STATE OF TENNESSEE
DEPARTMENT OF ENVIRONMENT AND CONSERVATION
Division of Remediation, Oak Ridge Office
761 Emory Valley Road
Oak Ridge, Tennessee 37830

July 19, 2024

RE: Addendum to the Final Zone 1 Remedial Investigation and Feasibility Study for a Supplemental Ecological Evaluation at the East Tennessee Technology Park, Oak Ridge, Tennessee (DOE/OR/01-2561&D3/A1)

All ETP Z1 COEC
exceedances overlaid

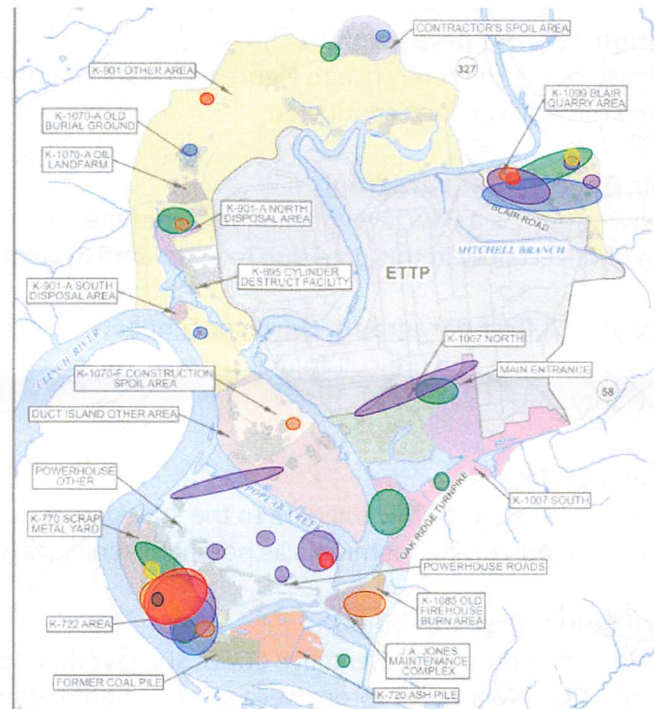
7. Please consider adding a figure like the one below showing COEC exceedances in relation to habitat areas.

(combo of Addendum
Figures 8-14)
